Docket Item # 6  
BAR CASE # 2007-0070

BAR Meeting  
July 9, 2008

**ISSUE:** Alterations and addition  
**APPLICANT:** Art Underfoot, Inc.  
**LOCATION:** 1203 King Street  
**ZONE:** KR/King Street Retail

Figure 3: Plat showing proposed addition

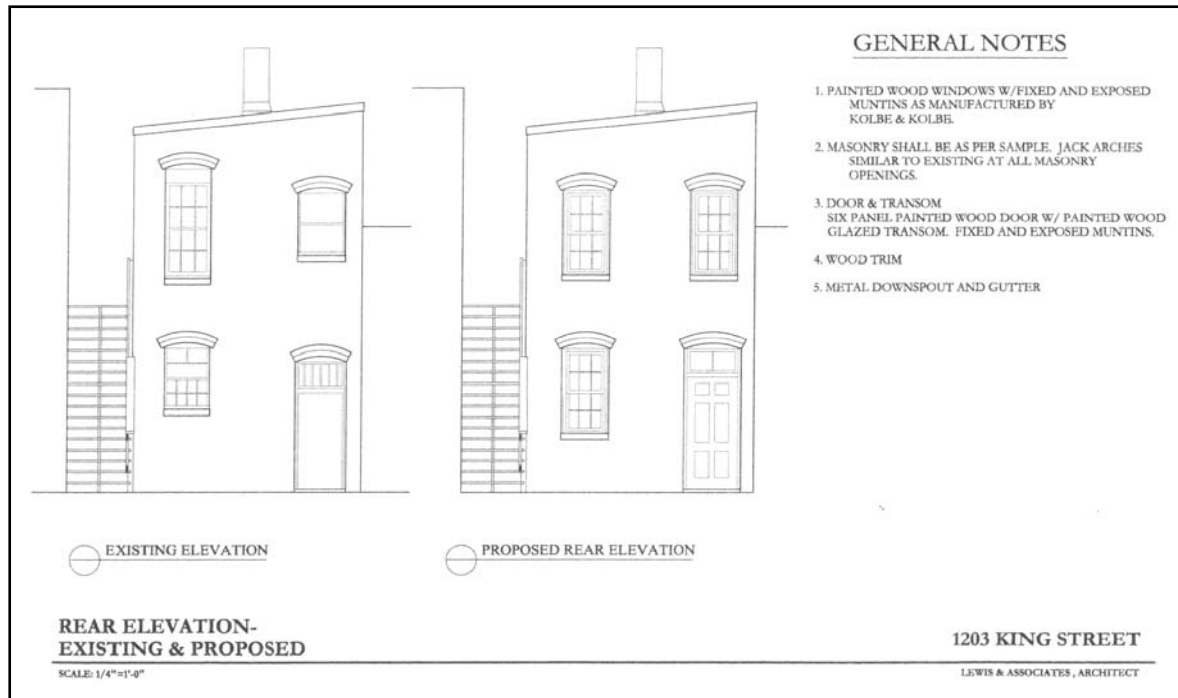
**REASON:** The Board asked for more accurate drawings clearly showing the proposed windows and doors, as well as the arches over the windows, and asked for a site plan demonstrating the size and location of the proposed addition. The Board also discussed whether the existing flounder-style portion of the building was historically significant.

- F-1 There are several existing and proposed openings on the North side of the property that appear to be within 5 feet of the interior lot line. The alteration of the structure shall comply with C-1 below.

- C-1 All exterior walls within 5 feet from an interior property line shall have a fire resistance rating of 1 hour, from both sides, with no openings permitted within the wall. As alternative, a 2 hour fire wall may be provided. This condition is also applicable to skylights within setback distance.

**Figure 4: Drawings showing existing and proposed rear elevation**

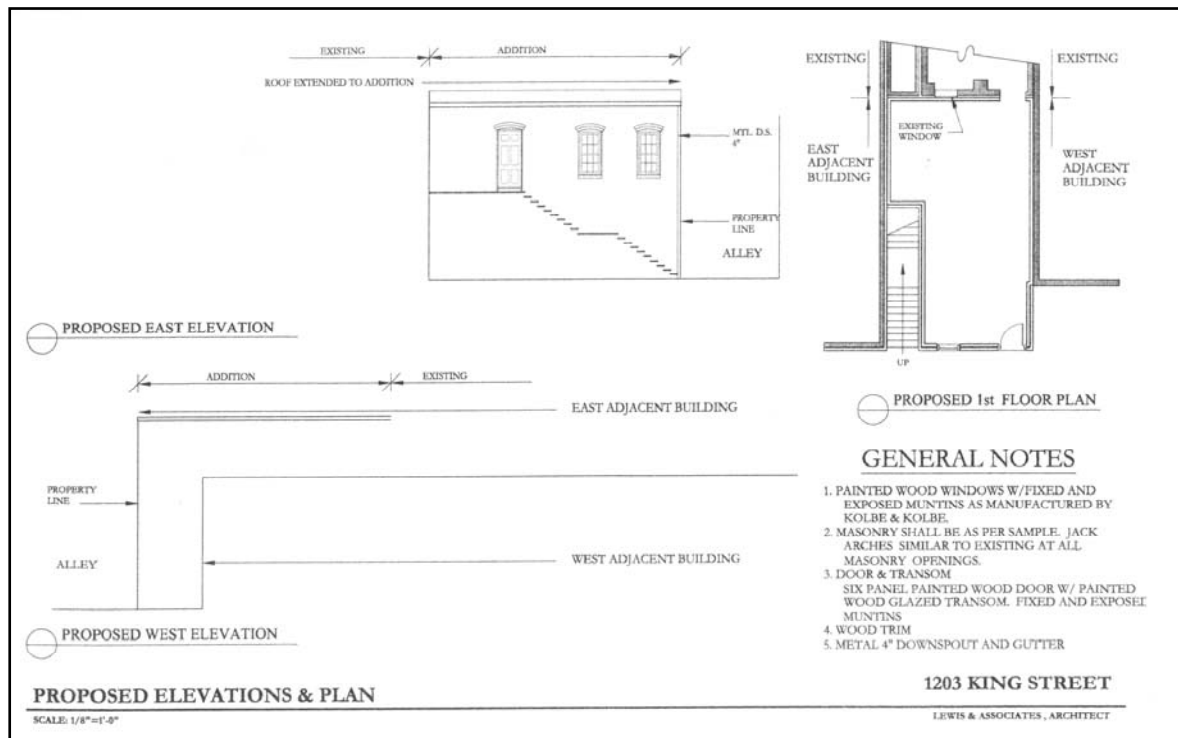
**REASON:** The Board believed that the new rear addition should mimic the existing rear addition and use, for example, brick jack arches over the windows; an appropriate transom; appropriately proportioned windows and no wood shingles. The members agreed that new drawings were needed before the Board could take action.

1. That the building permit drawings are revised to show the transom located directly over the door;
2. That the windows be two-over-two, double-hung, double-glazed, true or simulated divided light wood windows, with Staff to approve prior to filing for a permit;

3. That the applicant work with Staff to identify a more appropriate rear door; and,
4. Call Alexandria Archaeology immediately (703-838-4399) if any buried structural remains (wall foundations, wells, privies, cisterns, etc.) or concentrations of artifacts are discovered during development. Work must cease in the area of the discovery until a City archaeologist comes to the site and records the finds.
